PIC18FXX2 Rev. C1 Silicon/Data Sheet Errata

The PIC18FXX2 Rev. C1 parts you have received conform functionally to the Device Data Sheet (DS39564B), except for the anomalies described below.

In the Device Data Sheet (DS39564B), the following clarifications and corrections should be noted.

FIGURE 1: PINOUT DIAGRAM FOR PIC18F442/452, 44-PIN QFN PACKAGE

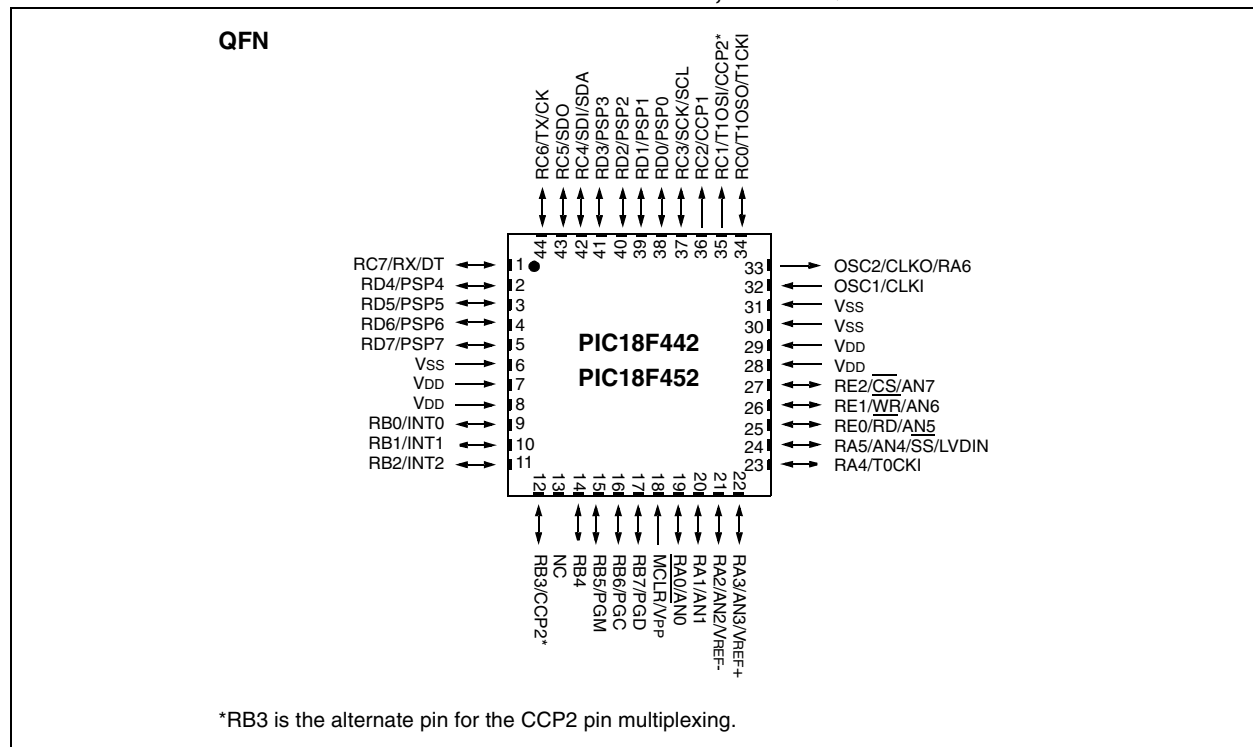
PIC18F442 and PICF452 devices are now offered in 44-pin, near chip scale micro lead frame packages (commonly known as “QFN”). This packaging type has been added to the product line since the latest revision of the Device Data Sheet.

1. The “Pin Diagrams” on pages 2-3 of the Data Sheet are amended with the addition of the 44-pin QFN pinout, shown in Figure 1.
2. Table 1-3 of **Section 1.0 “Device Overview”** is replaced with an updated version which adds a column for QFN pin assignments. A row is also added for previously unlisted NC pins. All new information is indicated in **bold**.

FIGURE 3: 44-PIN QFN PACKAGE

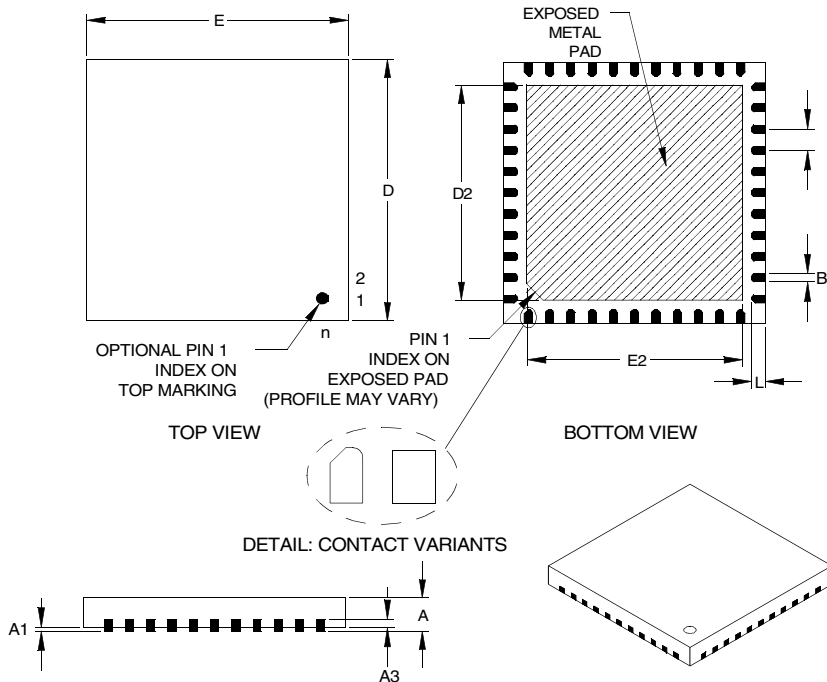
4. **Section 24.2 “Package Details”** is amended to include the mechanical drawing of the 44-pin QFN package, shown in Figure 3.
5. In the **“PIC18FXX2 Product Identification System”** (page 329), the “Package” options are amended to include the new line item: ML = QFN
